RECALL 25V682 / 2025-545 REMEDY INSTRUCTIONS

Make(s): SEE BELOW Model(s): SEE BELOW Model Year(s): 2016 - 2026	Repair Code: RC-003-13-00-004757 Allotted Time: .20 HRS. Inspection Code: RC-003-05-00-004756 Allotted Time: .10 HRS
	Concern: The charge line may not have over-current protection.	Photo(s) Required: NO Prior Authorization Required: YES Part(s) Kit Number: N/A Part(s) Return: N/A

CERTAIN – 2016 - 2026 – SALEM TRAVEL TRAILERS
CERTAIN – 2016 - 2026 – WILDWOOD TRAVEL TRAILERS

FIGURE 1 – INCORRECT

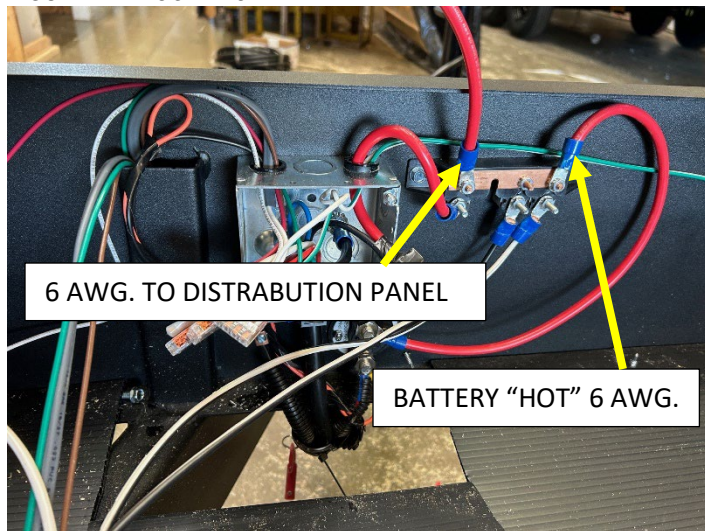
STEP 2: IF THE 6 AWG. WIRES ARE CONNECTED AS SHOWN IN FIGURE 1, FIGURE 2 OR FIGURE 3, MOVE ON TO THE REMEDY;

- INCORRECTLY WIRED EXAMPLES -

STEP 1: LOCATE THE 6 AWG. WIRE ON THE REAR POST OF THE MINI-BREAKER. LOOSEN THE NUT AND REMOVE THE WIRE/EYELET;

STEP 2: INSTALL THE NUT BACK ONTO THE POST YOU REMOVED IT FROM AND TIGHTEN DOWN, ASSURING IT IS SECURE;

STEP 3: REMOVE THE NUT FROM THE LOWER POST ON THE REAR MINI-BREAKER;

- REMOVE THE SMALLER WIRE/EYELET FROM THE POST;
- INSTALL THE 6 AWG. WIRE/EYELET ONTO THE POST;
- RE-INSTALL THE SMALLER WIRE/EYELET ONTO THE POST. ROTATE THE SMALLER WIRE WHERE THE EYELET CRIMPS DO NOT OVERLAP. IF THEY OVERLAP, THEY MAY BECOME LOOSE.
- INSTALL THE NUT AND TIGHTEN, CLAMPING THE TWO WIRE/EYELETS TOGETHER, ENSURING PROPER SECUREMENT;
- THE REMEDY SHOULD NOW MATCH FIGURE 2;

FIGURE 4 – CORRECT

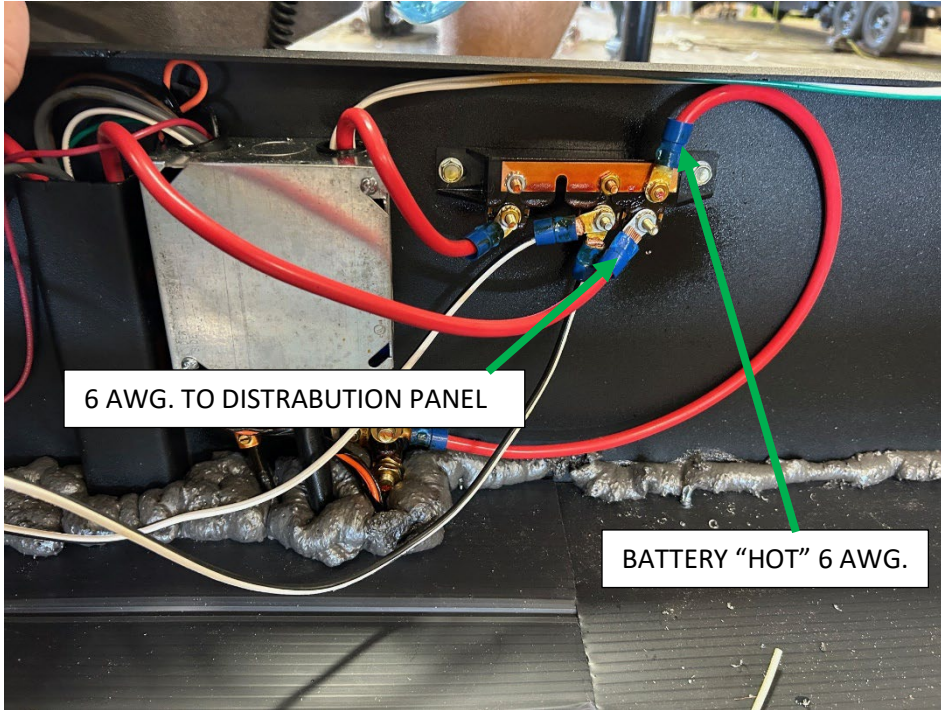
- IF THE 6 AWG. WIRES ARE CONNECTED AS SHOWN IN FIGURE 4 OR FIGURE 5 CLAIM THE INSPECTION, WORK COMPLETED.

- CORRECTLY WIRED / REMEDY -
